CITY OF HOBART

## **CITY PLANNING COMMITTEE MEETING (OPEN)**

**MONDAY, 2 MAY 2016**

**6.1.2 SALAMANCA LAWNS (AKA 40 SALAMANCA PLACE),  
HOBART - MOBILE FOOD VENDOR SITES - PLN-16-00167-01 -  
FILE REF: S70-64-1**

Image 2. Excerpt from Site Plan as submitted 30 March 2016.

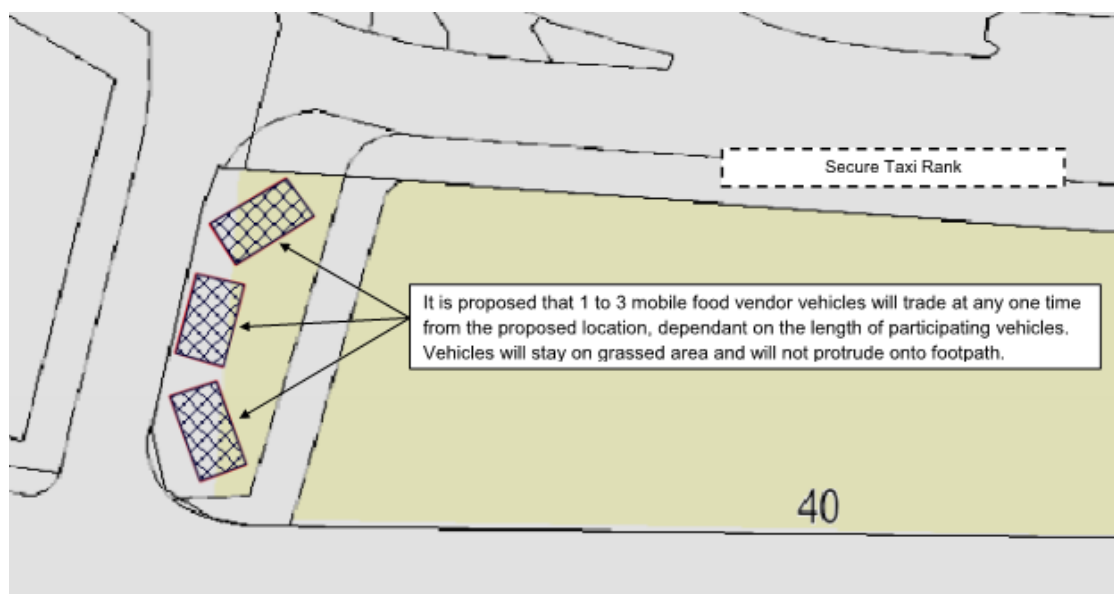
- 6.7.10. A condition is recommended to ensure consistency with the public space guidelines of the planning scheme requiring that the buildings (mobile food vendor vehicles) must be placed parallel to Morrison Street, and to ensure there is no reduction in sight lines for drivers of vehicles travelling towards the intersection along Morrison Street towards the statutory sign, Salamanca Place or towards pedestrians in the area.

- 7.2. The proposed commercial (ephemeral) buildings in the public urban space are considered generally consistent with the provisions of the planning scheme; however a condition has been recommended to bring the proposal more into conformity with the form and pattern of buildings, to ensure pedestrian movement is not impeded, and to ensure that traffic safety is not compromised.

PLNs1 An amended site plan must be submitted and approved, prior to the commencement of the use. The amended site plan must:

- (a) show a 2 metre setback from the Morrison Street kerb to the back of the mobile food vendor vehicles along the full length of the site;
- (b) show the placement of the mobile food vendor vehicles parallel with the Morrison Street kerb line; and
- (c) show a 1 metre setback between the service side of the mobile food vendor vehicles and the pedestrian footpath to the east of the site.

Image 8. Excerpt from Figure 9 Public Urban Space Types showing subject area as 'Cove Floor'.

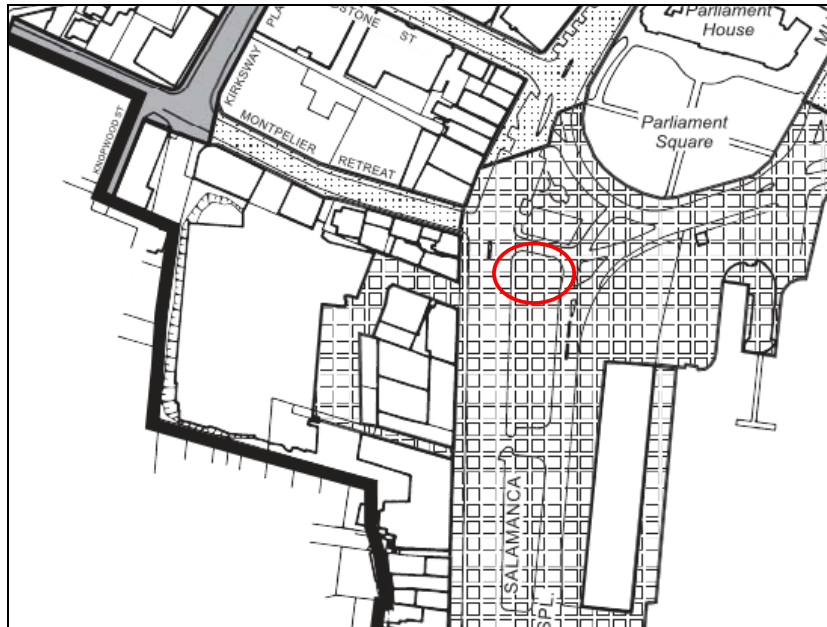
- 6.7.4. In 'Public Urban Space Types' Plan (Figure 9) the site is in the 'Cove Floor area' (see image 8 above).
- 6.7.5. Section 2.4 of the *Sullivans Cove Planning Review* (1991) does not give specific guidance on ephemeral buildings. However the general design principles are consistent with those considered below under clause 24.4.8B.
- 6.7.6. Clause 24.4.8B provides guidelines for the design of civic works and public street furniture in primary and secondary spaces (as indicated in Figure 7 of the scheme, see Image 9 below). Although this site is not in either of these spaces, but is surrounded by 'primary space', clause 24.4.6 requires that the proposal is compatible with the guidelines, and as such the guidelines for primary spaces will be specifically considered.

Image 9. Excerpt from Figure 7 of the scheme shows the site (in red circle) surrounded by 'primary space' (hatched area).

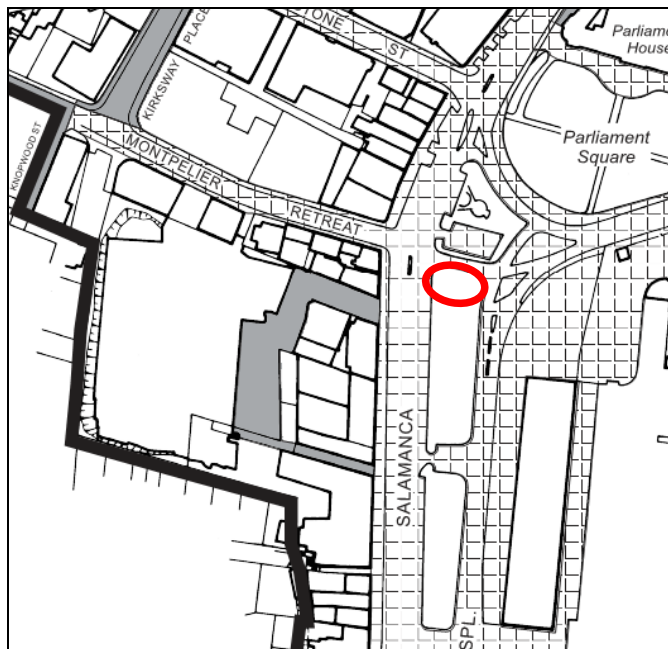
6.7.7. Section 24.4.8B Primary space guidelines provide as follows:

Figure 6: Showing the proposed changes to the building line of the building. The blue line indicates the proposed building line, and the green line shows the existing building line.

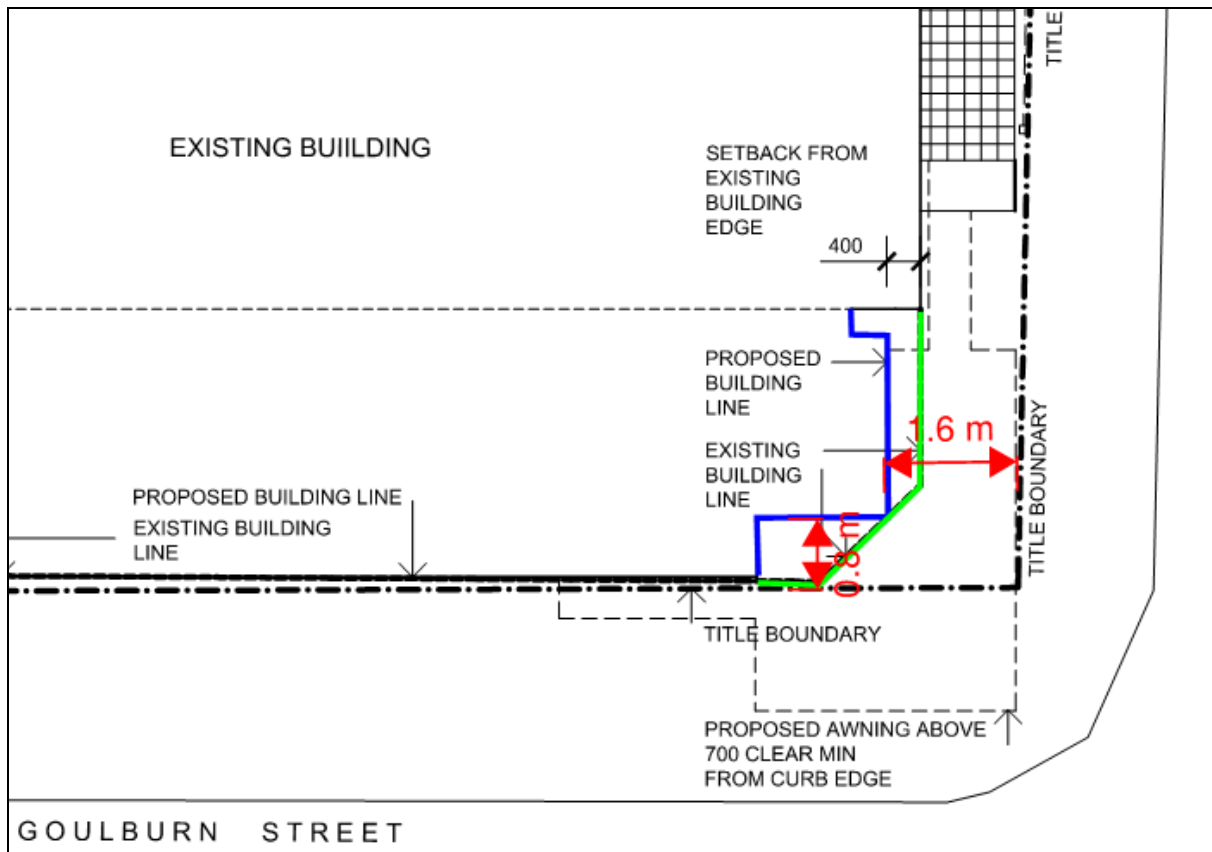
- 6.9. Each performance criterion is dealt with separately below.
- 6.10. Non-dwelling development (front setback) – clause 11.4.9 P1
  - 6.10.1. The proposal includes the demolition of the existing front extension and its replacement with a new front extension. The setback of the new extension will be, for the most part, the same as the setback of the existing front extension. It is built to the front boundary (Goulburn Street), except at the corner, where it is stepped in. The maximum setback is still less than 1m from Goulburn Street at its maximum, and less than 2m maximum from Barrack Street.

**NOTE****PARKING:**

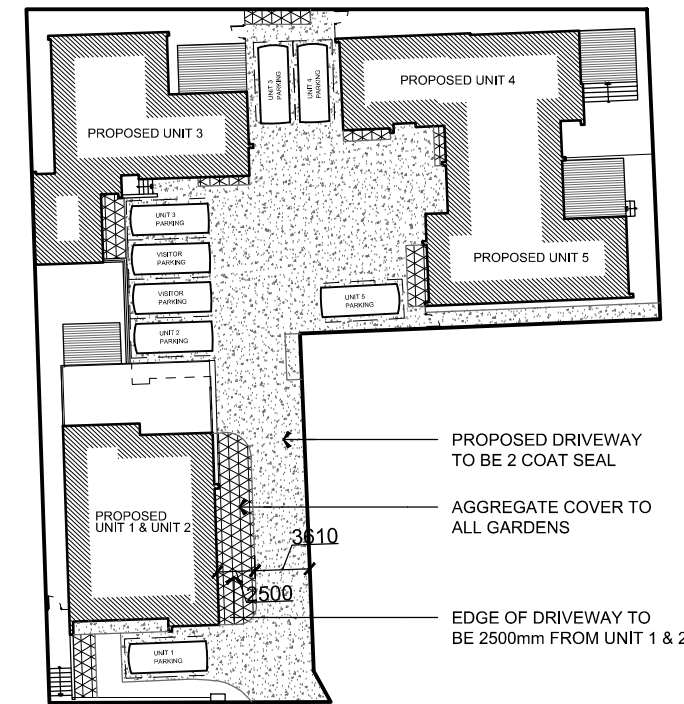
UNDER THE HOBART PLANNING SCHEME, IT IS REQUIRED THAT 9 PARKS SPACES BE PROVIDED. AS THERE IS ONLY 8 PROVIDED, THE FOLLOWING SHOULD BE CONSIDERED,
